Sub: Compendium of Advance Correction Slips to ACTM.

Sub: Advance Correction Slip No. 34 to Railway Manual of AC traction (ACTM) Vol. II Part II Appendix-I Para No. 18.11, ACTM Volume-II, Part-II, Fig. A1.10 & ACTM Vol. II Part-I, Chapter-VII, para 20703-Sub Para 4(i) with regard to distance between OHE structures and signal post.

ACTM Correction slip no. 34 dated 19.12.2022

**Sub: Advance Correction Slip No. 11 to Railway Manual of AC traction (ACTM) Vol. II Part II
Appendix-10, Page no 298 with regard to use of 9-tonne adjusters on both contact and catenary
wires at termination locations.**

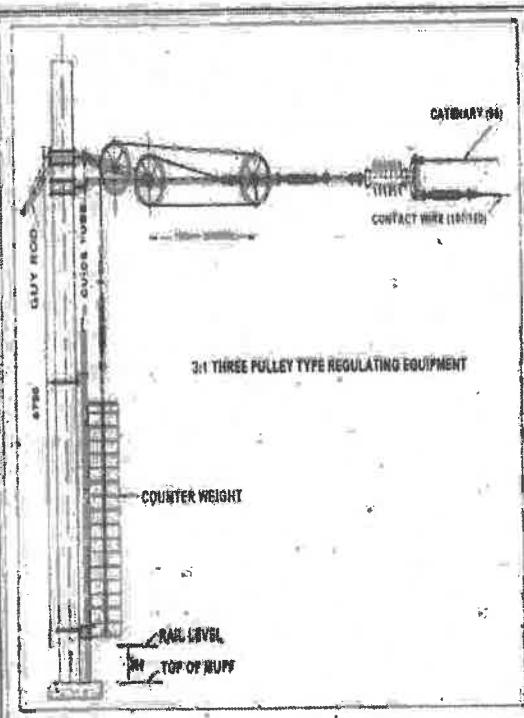
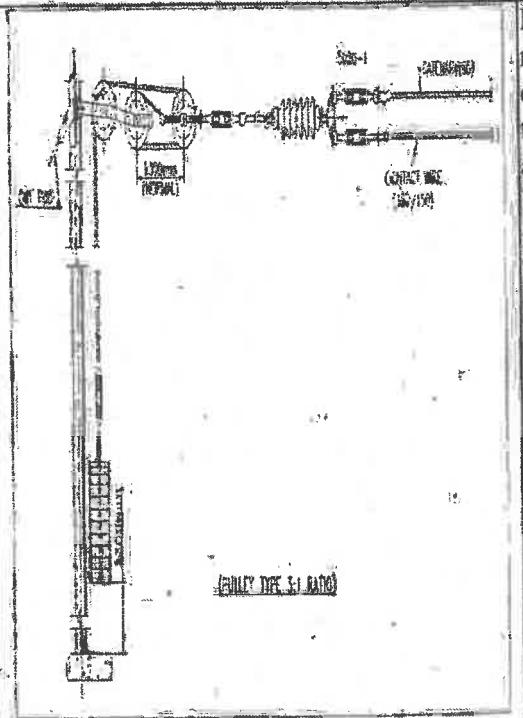
Page no	Existing Provision in ACTM Nov- 2022	Proposed Modification	Justification
98			<p>Regarding modification in the diagram in relation to use of 9-tonne adjusters w.r.t. RDSO's drawing no ETI/OHE/G/0312 1 (Mod F).</p>
